# Access Compliance Report

## Public Rights-of-Way

### (Curb Ramps)

Intersection ID: 3053	Main Street: WHITE_STAG_DR	Cross Street: WHITETAIL_CT	Location: NE
ADA ID: 50F0C013D72B	Ramp Type: Perp	Initial Pass/Fail: Fail	Overall Compliance: No
Severity Score: 48.75			
Codes/Mitigation Info/Possible Solution		Field Measurements/Component Compliance

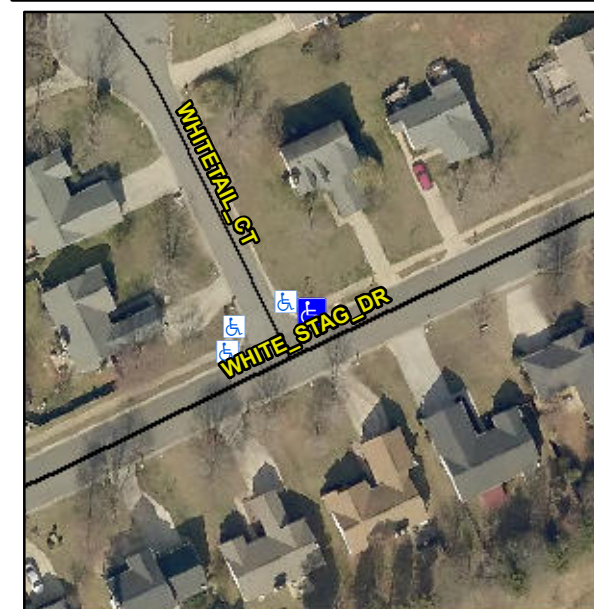
**Not Found, R304.5.1, R304.2.2, R304.5.3**

Compliance	Description	Data	Compliance	Description	Data
N/A	Ramp Length (in)	46.0	No	Ramp Slope (%)	9.3
No	Ramp Width (in)	31.0	No	Ramp XSlope (%)	2.8
N/A	Flare Type LT	N/A	N/A	Flare Type RT	N/A
N/A	Flare Slope LT (%)	N/A	N/A	Flare Slope RT (%)	N/A
N/A	Flare Traversable LT?	N/A	N/A	Flare Traversable RT?	N/A
N/A	Landing Length (in)	N/A	N/A	DWS Provided?	N/A
N/A	Landing Width (in)	N/A	N/A	DWS Contrast?	N/A
N/A	Landing Slope (%)	N/A	N/A	DWS Length (in)	N/A
N/A	Landing X Slope (%)	N/A	N/A	DWS Full Width?	N/A
N/A	Landing Curb? (Y/N)	N/A	N/A	DWS Offset (in)	N/A
N/A	Shared Landing?	N/A			
N/A	Gutter Ponding?	N/A	N/A	Gutter Slope (%)	N/A
N/A	Gutter Lip Ht (in)	N/A	N/A	Gutter X Slope (%)	N/A
N/A	Painted X Walk1?	No	N/A	Painted X Walk2?	N/A
	X Walk 1 Direction	To S		X Walk 2 Direction	N/A
N/A	X Walk 1 Width (in)	N/A	N/A	X Walk 2 Width (in)	N/A
	X Walk 1 Slope (%)	6.3		X Walk 2 Slope (%)	N/A
	X Walk 1 X Slope (%)	1.3		X Walk 2 X Slope (%)	N/A

**Remove & Replace Entire Ramp.**
